2024 Standard Tender Documents for Unit Price Contracts

Information Session

March 28th, 2024

Sidewalk Joint Construction (SC5, SC14)

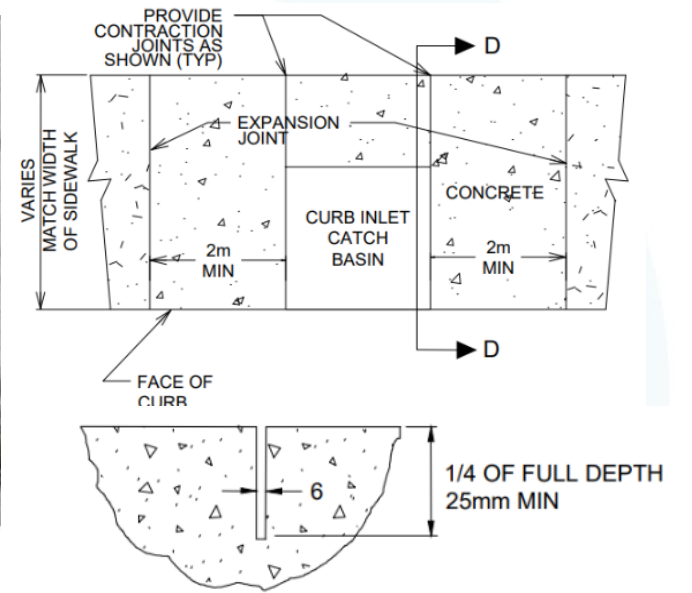
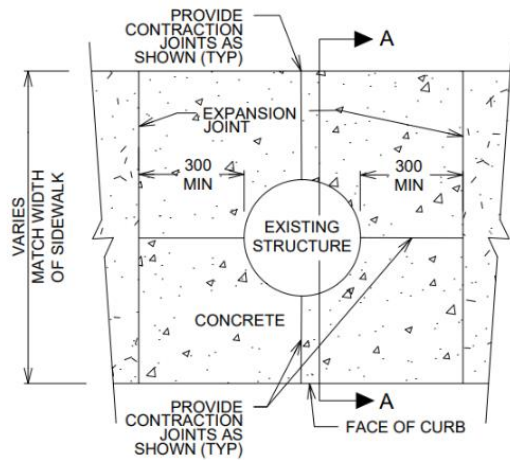
- Sidewalk joint placement has been revised on SC5 and SC14 try and alleviate unwanted shrinkage cracking
- Forming of joints in the sidewalk is to be by use of a Green Saw or by Hand forming. Beveled edges at top of concrete joints are no longer required.

Pin Curbs for Bike Lane Separation (NEW SC42, SC42.1, SC42.2)

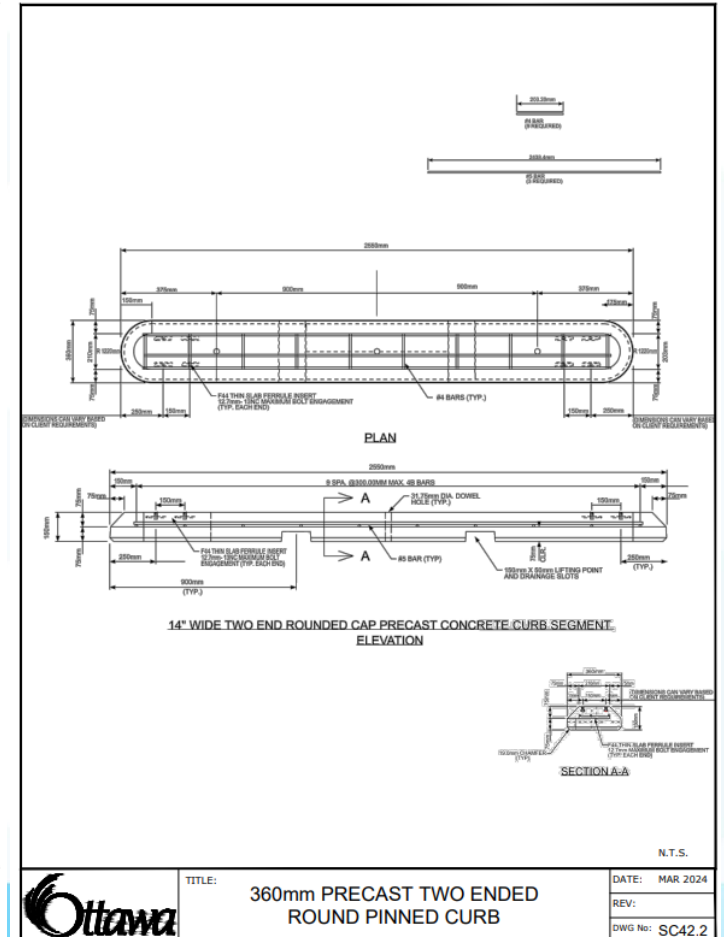
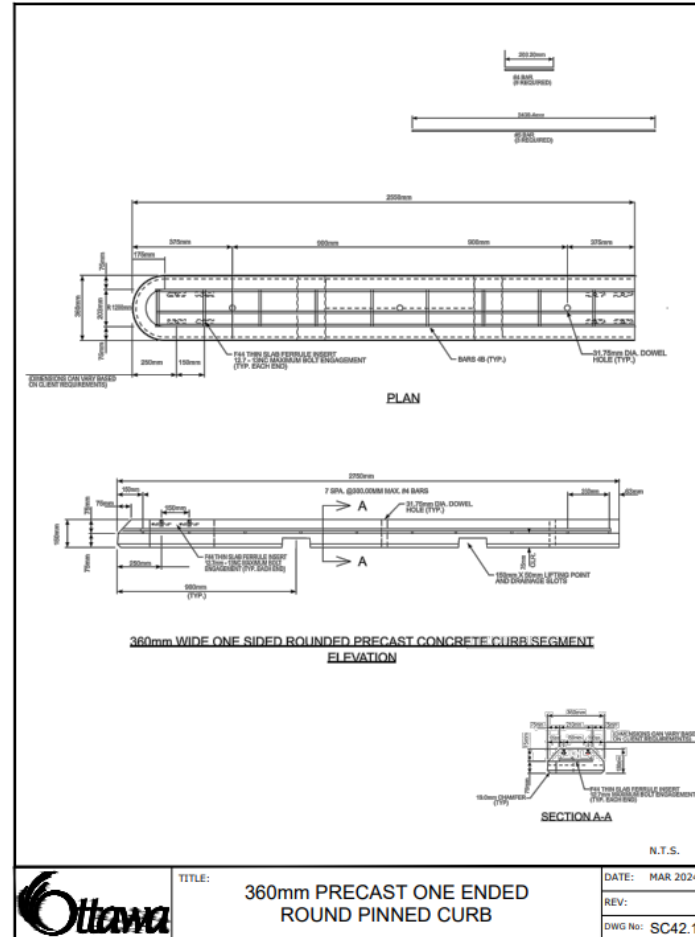
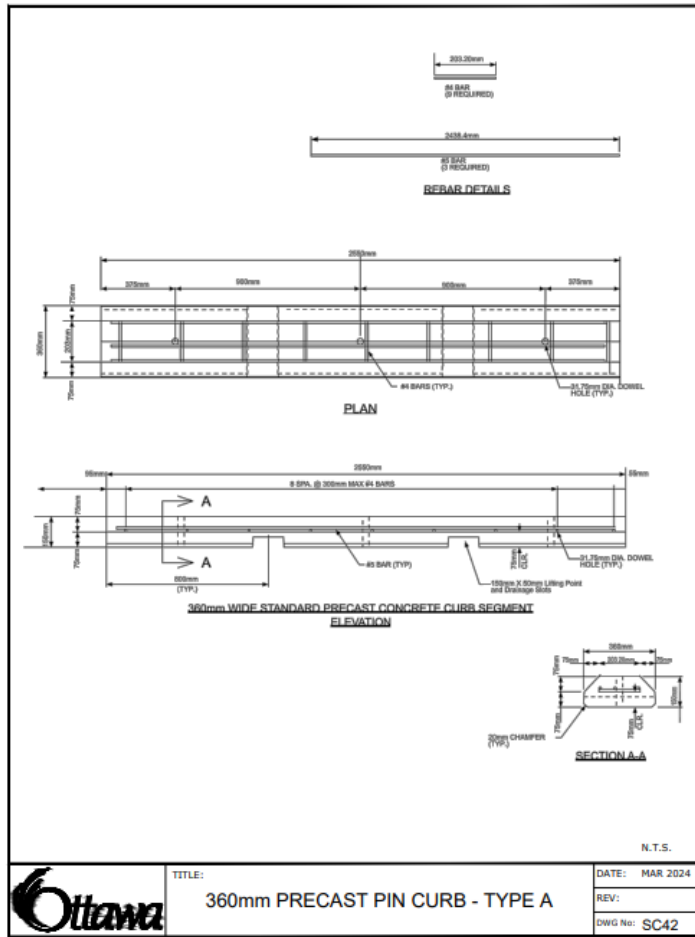
- New pin curbs for cycle and vehicle lane separation
